STORM SEWER IMPROVEMENTS to serve KELLOGG ILLINOIS ADDITION

AS BUILTS	
Contractor: McCullough Excavation, Inc. 9/06/2019	Project Inspector: Larry Gann KEMILLER ENGINEERING P.A. 117 E. Lewis, Wichita, KS 67202 (316)264-0242

PPD TITLE SHEET

SWS LINE 1

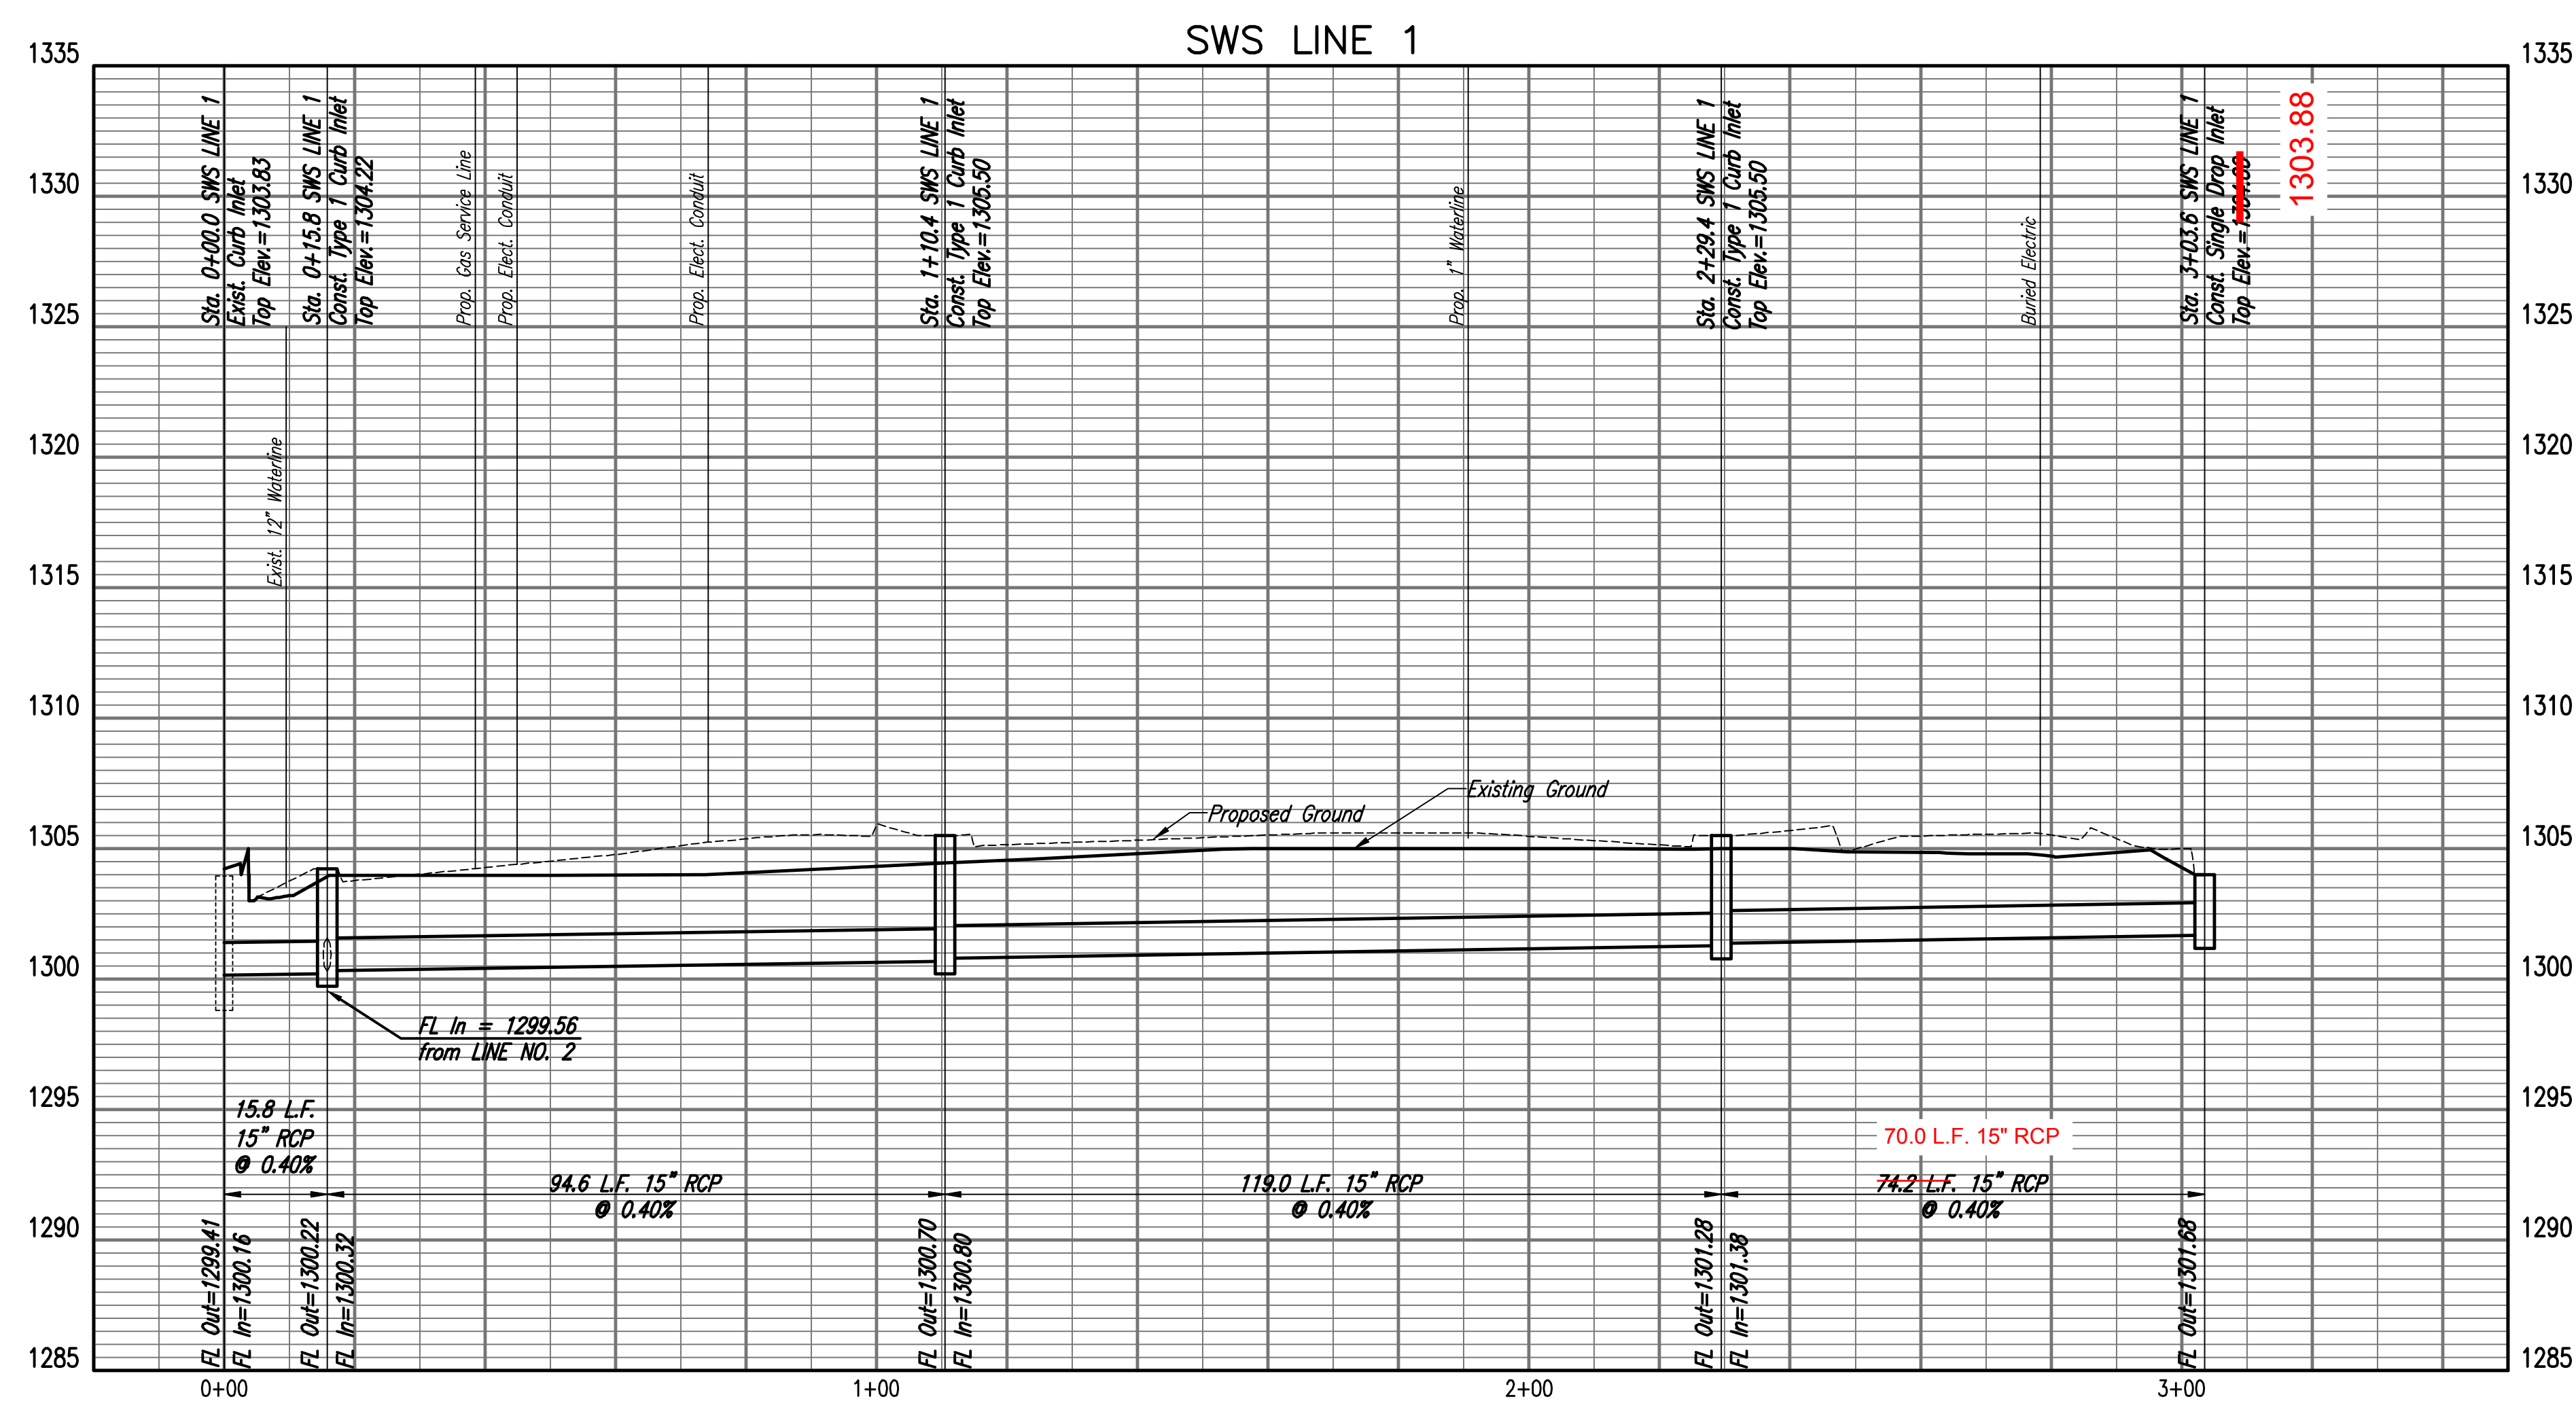
**MOVED
DROP
INLET
SOUTH
38"
CENTER
TO
CENTER**
